**Byers Gill Solar
EN010139**

8.24 Comments on Deadline 5 Submissions

Deadline 6 - December 2024

Landscape Section A: Carr House to Substation

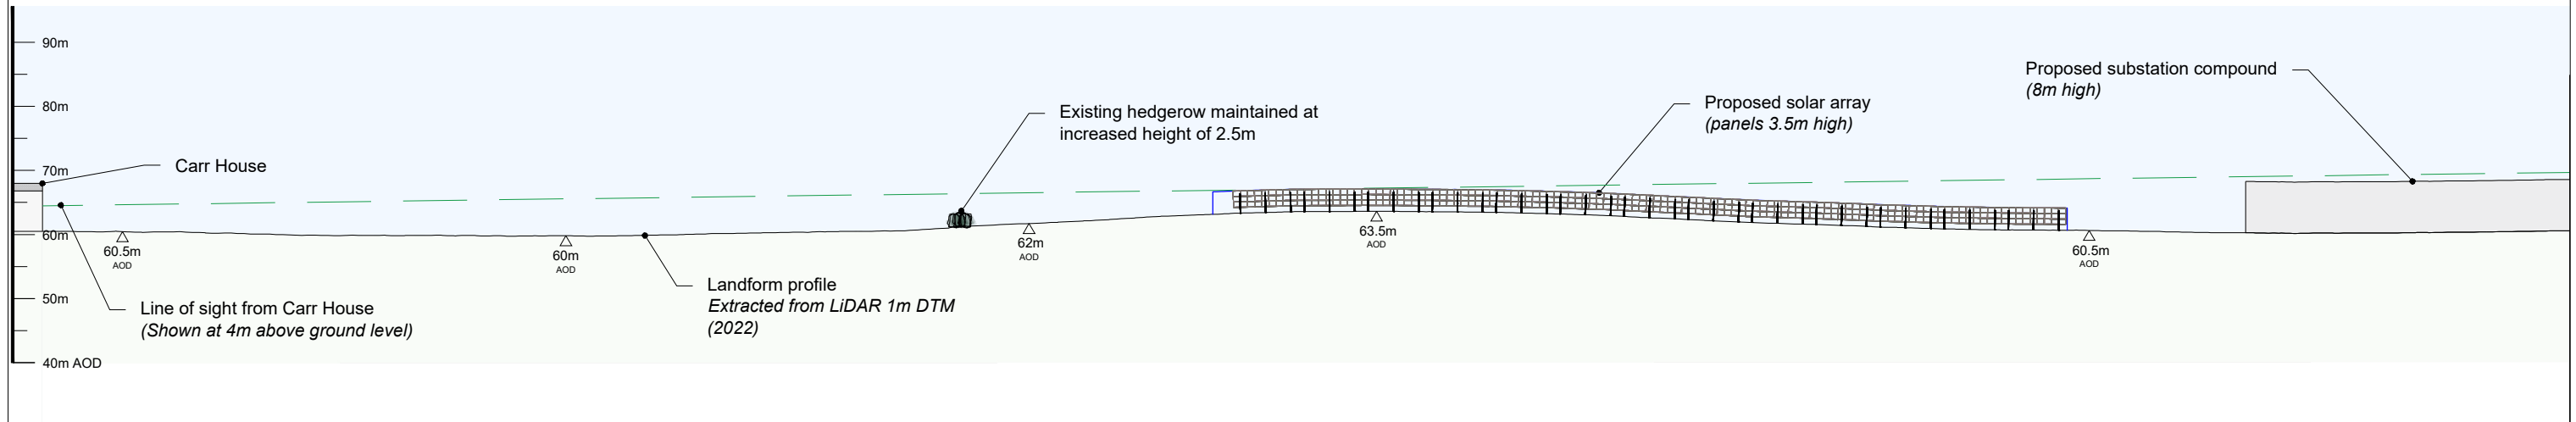
- 3.2.2. In its response to LSV 2.7 and LSV 2.9, the Applicant committed to providing cross-sections of planting proposals at Great Stainton and of Carr House respectively. These are provided at this Deadline, in Appendix A1 of this document.
